PCN#20251014001.2

**Qualification of CDAT as an additional Assembly/Test site for the Select Devices
Change Notification / Sample Request**

Date: October 14, 2025

Sample product shipping label (not actual product label)

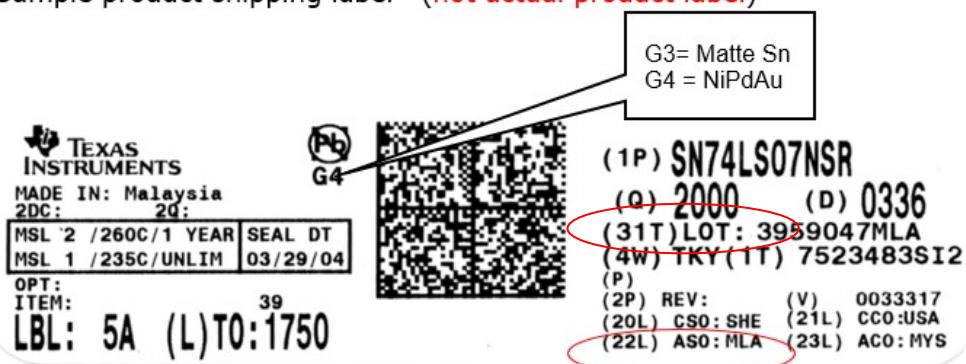
Changes to product identification resulting from this PCN:

Assembly Site	Assembly Site Origin (22L)	Assembly Country Code (23L)	Assembly City
HFTF	HFT	CHN	Hefei
HNA	HNT	THA	Ayutthaya
TFME	NFM	CHN	Economic Development Zone
CDAT	CDA	CHN	Chengdu
